**CITY OF CROSSLAKE
PLANNING COMMISSION/BOARD OF ADJUSTMENT**

PUBLIC HEARING NOTICE

Site Location: 37916 Forest Lodge Rd, Crosslake, MN 56442 on Rush Lake-GD

STAFF REPORT

CERTIFICATE OF SURVEY

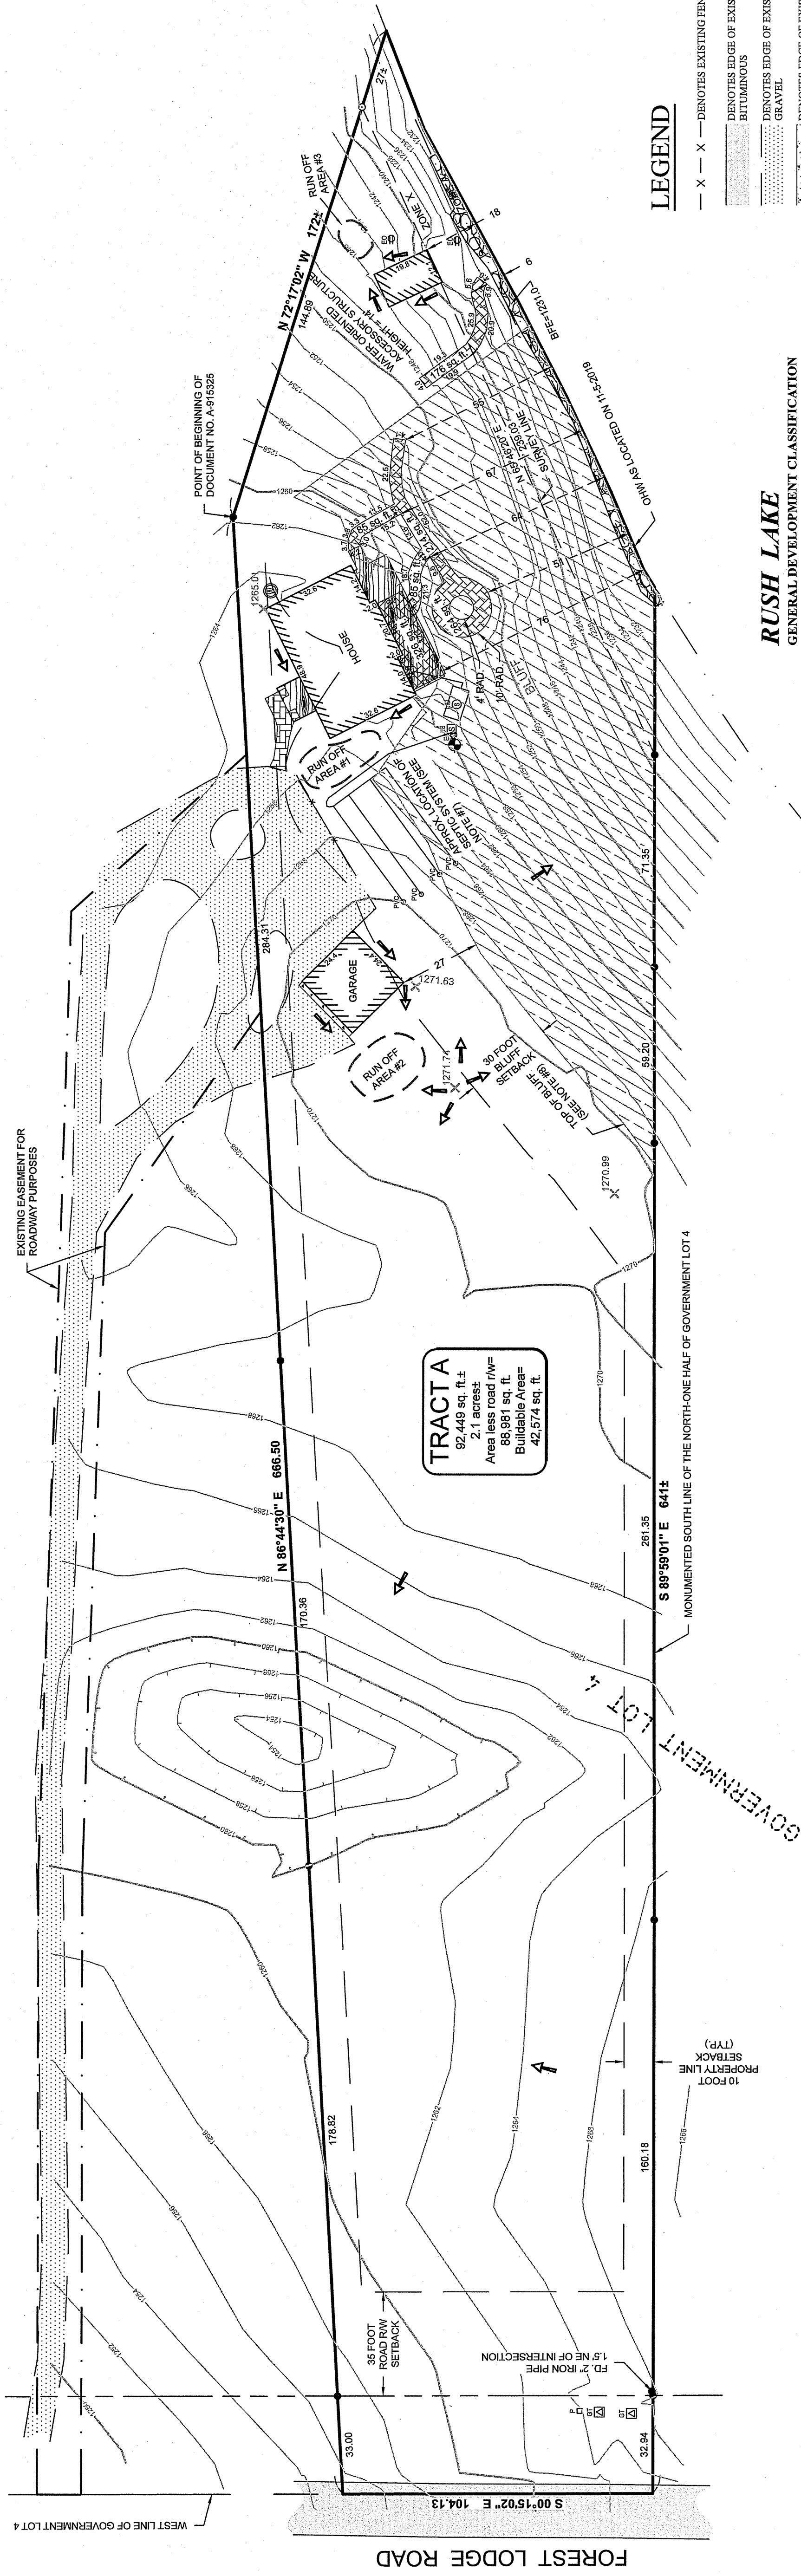
As shown on the certificate of survey dated 8-20-2020
